PERMIT ISSUED
Permit Number: 060341
AUG 11 2006
CITY OF PORTLAND

has permission to build a 2 story cape cod w/ attached 2 car garage

AT 15 TIDE MILL RD

City of Portland, Maine - Building or Use Permit Application

Drawing Name: Layout & Utilities Plan - Lot 18
Project: TIDE MILL ROAD, PORTLAND

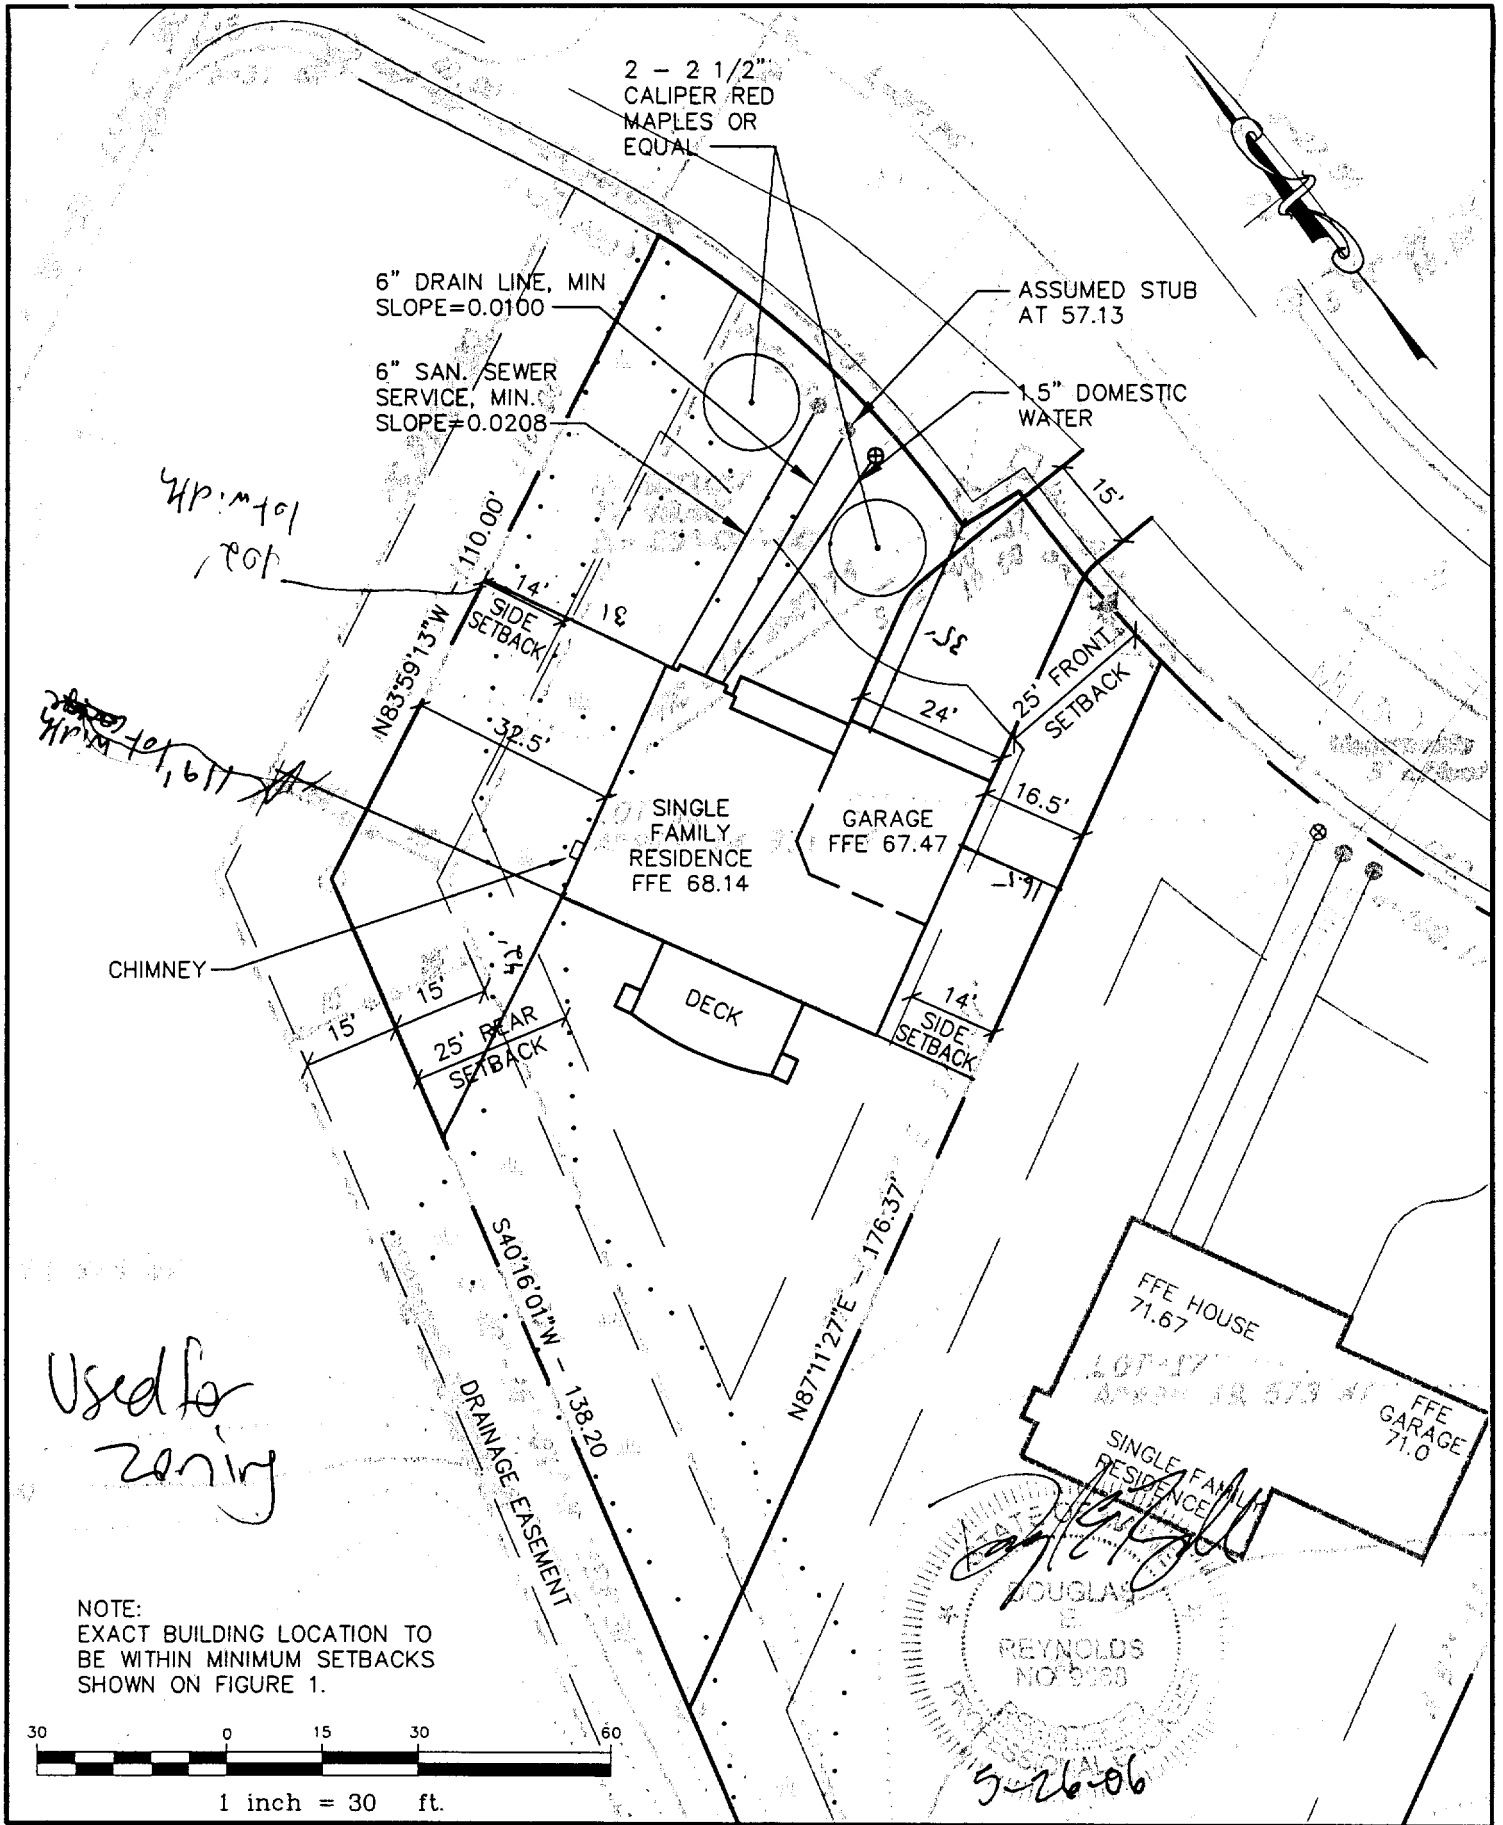
NOTE:
EXACT BUILDING LOCATION TO
BE WITHIN MINIMUM SETBACKS
SHOWN ON FIGURE 1.

- 3/17/2006-amachado: Left message. **We** need a full size set of building plans including scalable elevation plans that also show the right side elevation. The building plans have a porch and bay window that the site plan does not. There is no stamped boundary survey.
- 4/7/2006-amachado: Received Stamped boundary survey on March 20,2006. Still waiting for fullsize building plans.
- 5/26/2006-amachado: Mike DiPhilippo came in with revised site plan. Full size building plans came in on 4/26/06.
- 6/13/2006-GG: received approved site plan. /gg
- 6/26/2006-mjn: Faxed a list of plan deficiencies to architect and applicant. Got partially corected plans, will issue with conditions
- 6/23/2006-mjn: Left message with applicant regarding plan deficiencies.
